AGENDA

**CITY OF COLUMBIA TENNESSEE
BOARD OF ZONING APPEALS
STAFF REPORT**

**DOCKET/CASE/APPLICATION
NUMBER**
22-0200

Case #22-0183
Vulcan Quarry
TM 66 Parcels 20.25 & 20.26

Site Location
MAURY COUNTY
COLUMBIA, TENNESSEE

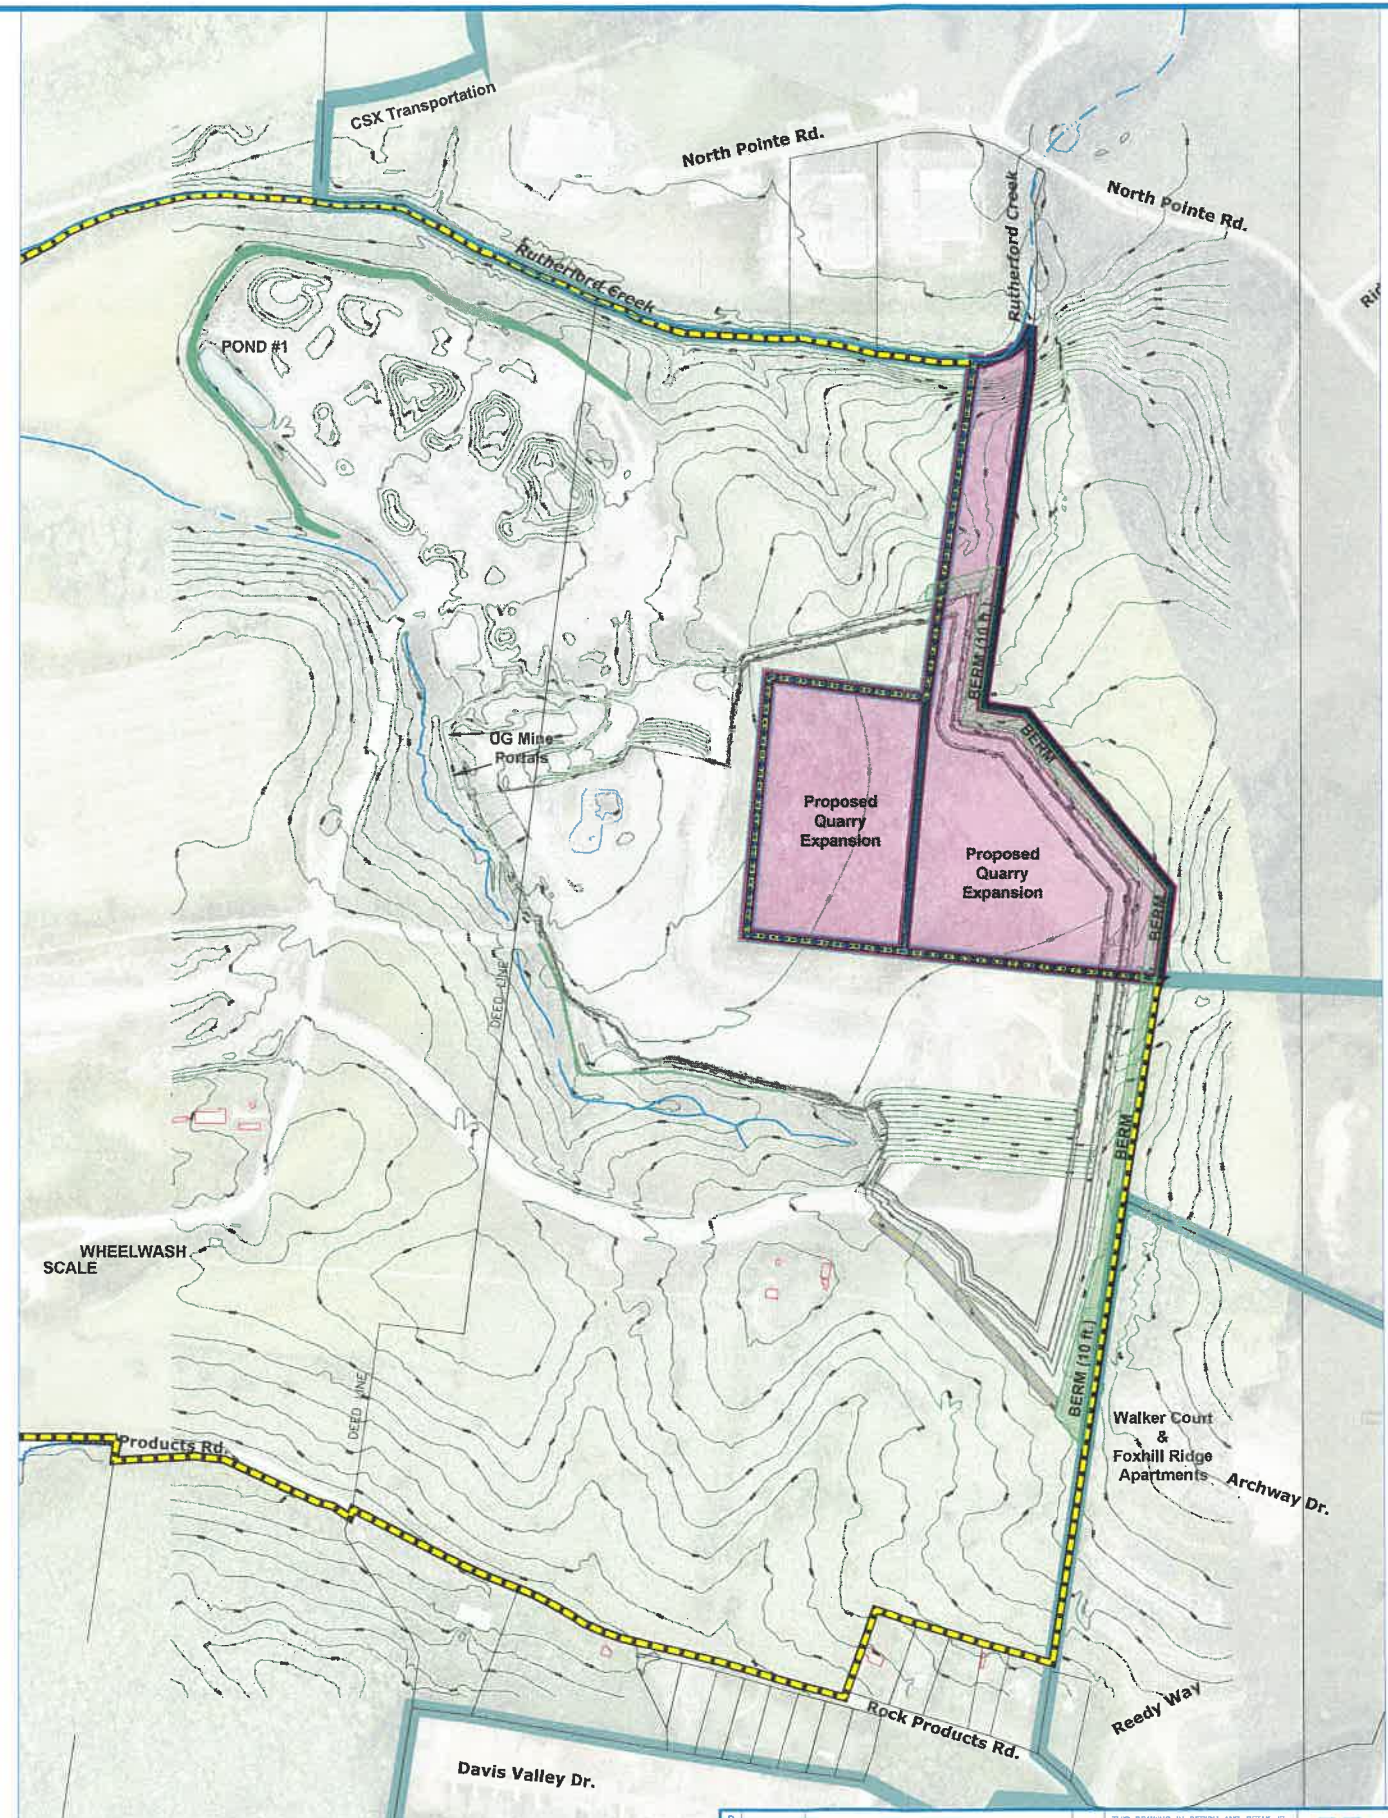
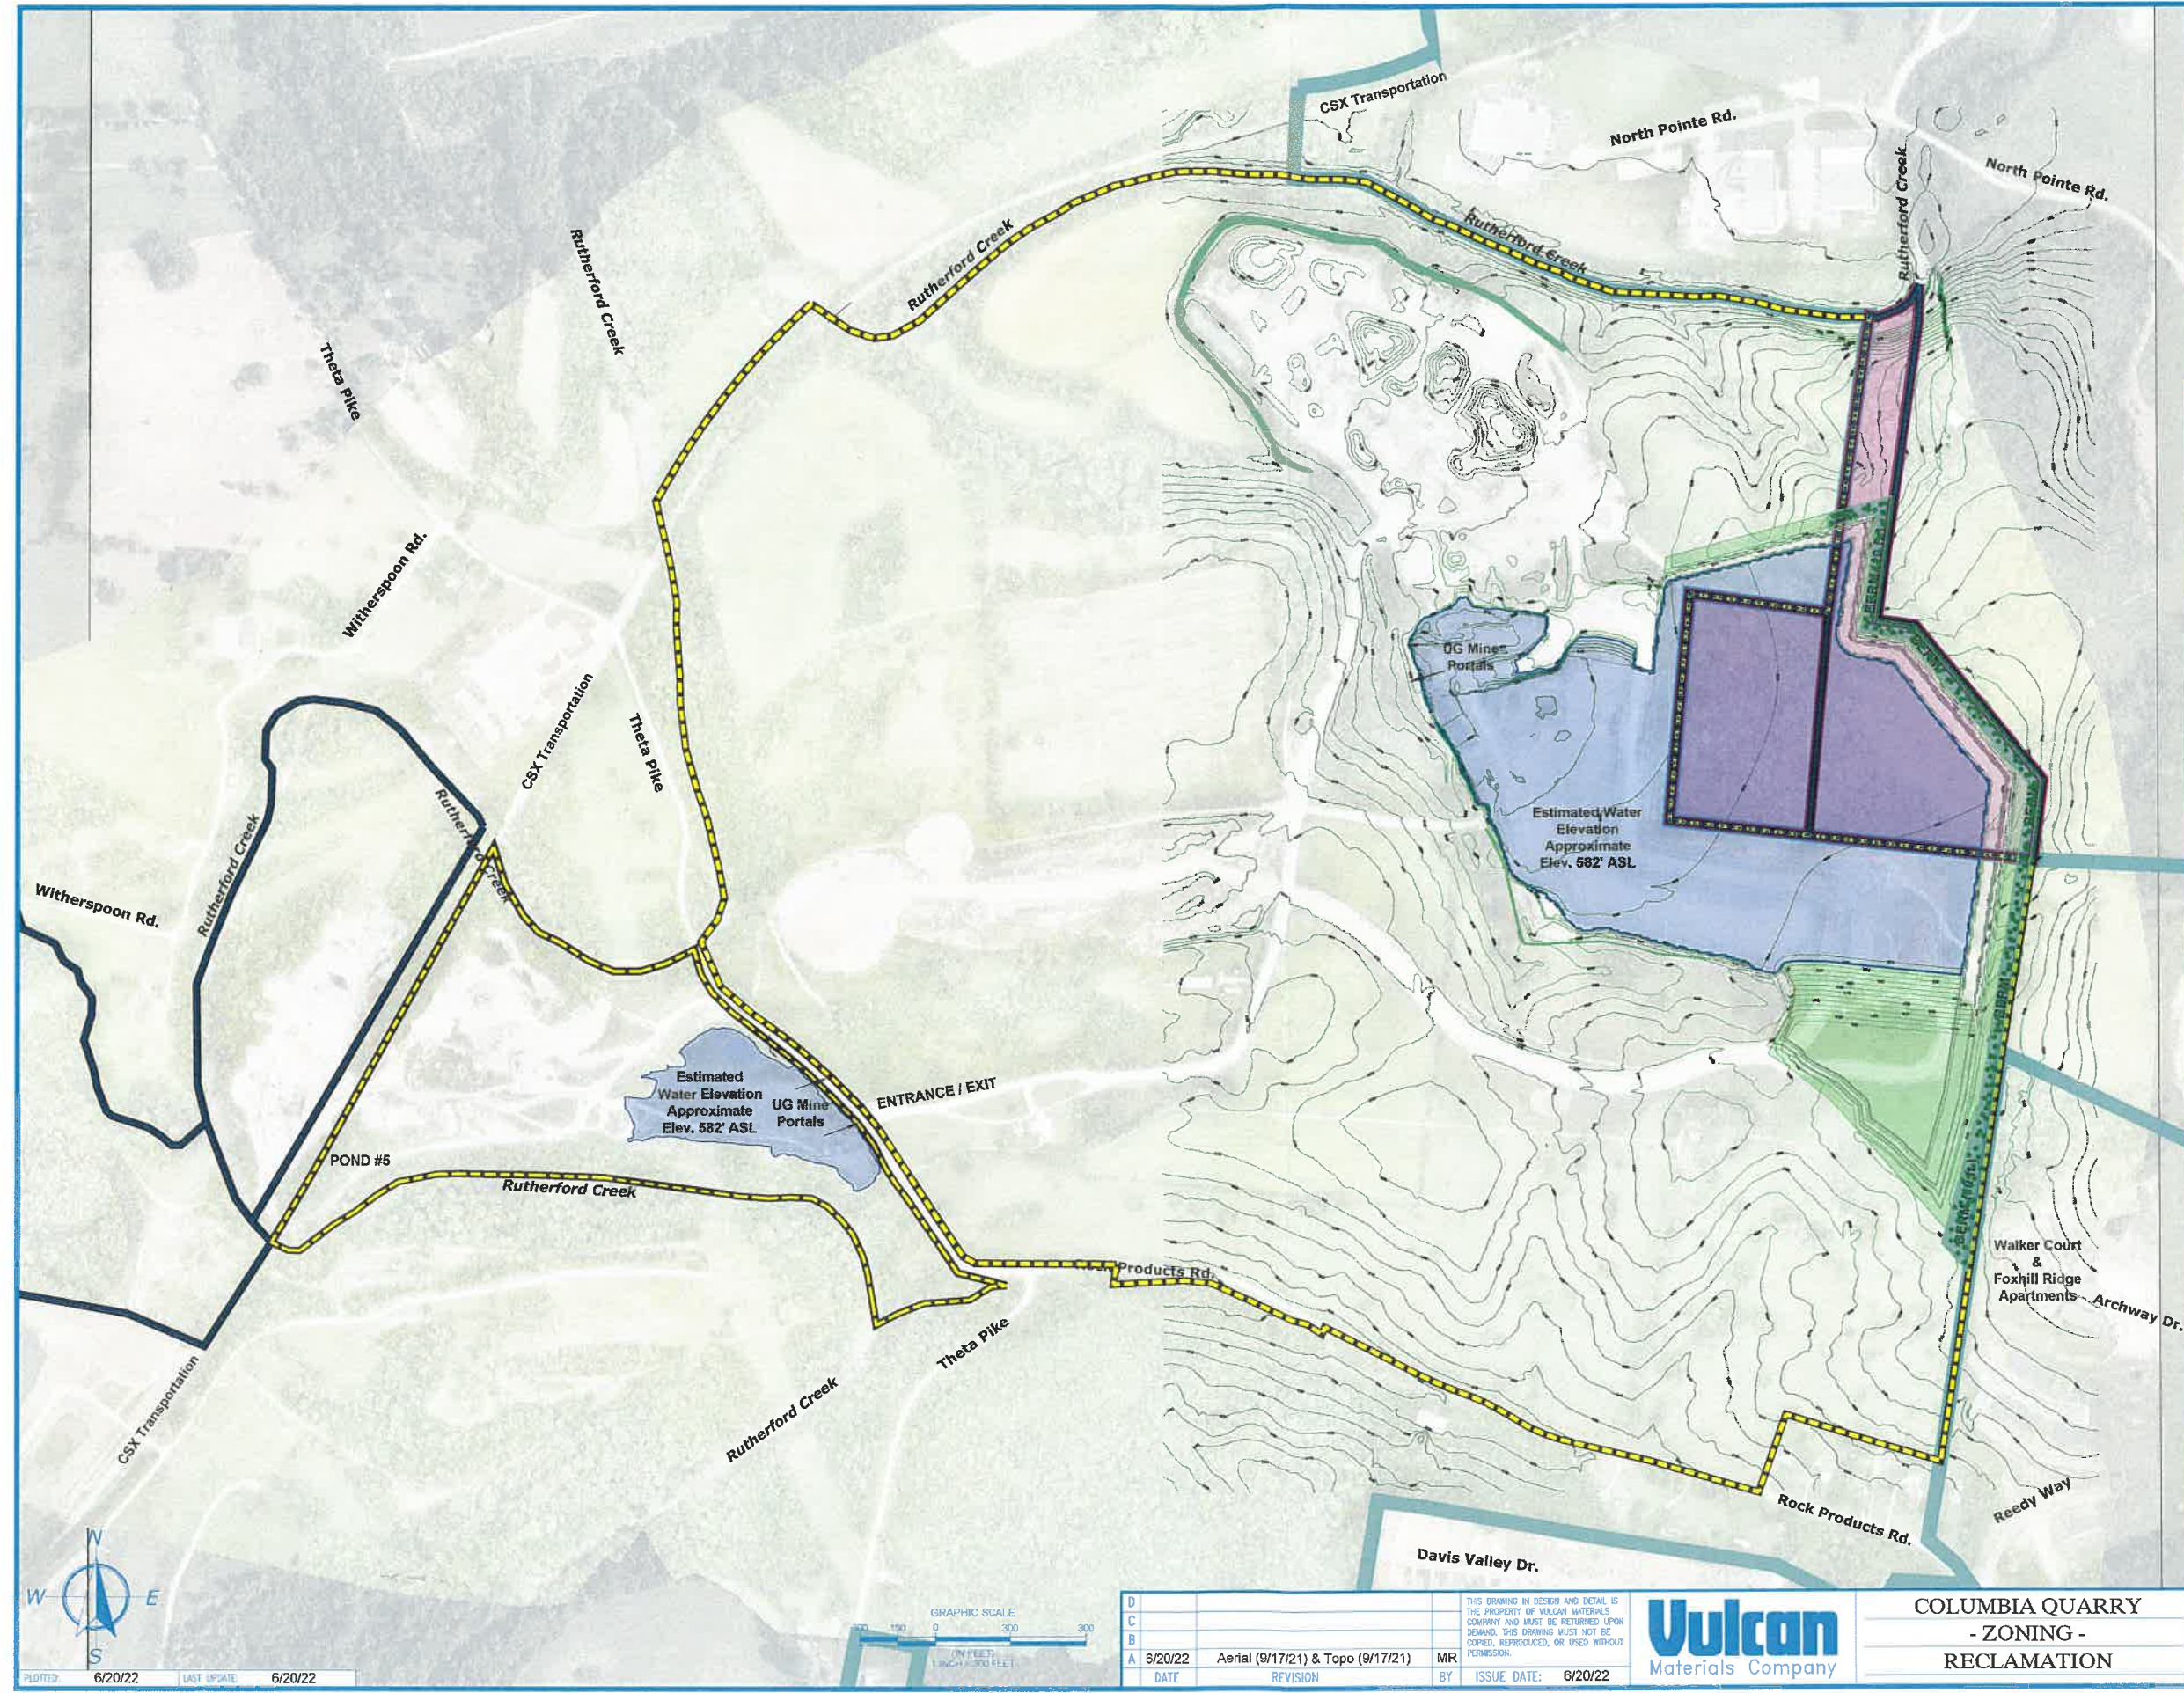
The Zoning Ordinance requires that every mining operation established in the city provide a plan for restoration of the site (8.3.1.C.1). The applicant's plan is illustrated at Exhibit I of the submittal and further described in the letter from the applicant's representative. Specifically, the applicant proposes to reduce the slope of the site using fill materials. The remaining "pit" will become a water feature and the site will be planted with native foliage. The Ordinance does not prescribe technical requirements for restoration of the site. The applicant's proposal appears to be in keeping with industry standard and the common practice for retiring exhausted quarries across Tennessee.

The Ordinance requires that a detailed site plan accompany every request to establish or expand a quarry operation (8.3.1.C.4). The applicant has provided a site plan comprised of Exhibits A through I of the submittal. The plan depicts the existing contours of the site and its vicinity at 2-foot intervals (8.3.1.C.4a and b), the method of drainage (8.3.1.C.4d), and the plan for restoring the site (8.3.1.C.1 and 8.3.1.C.4d).
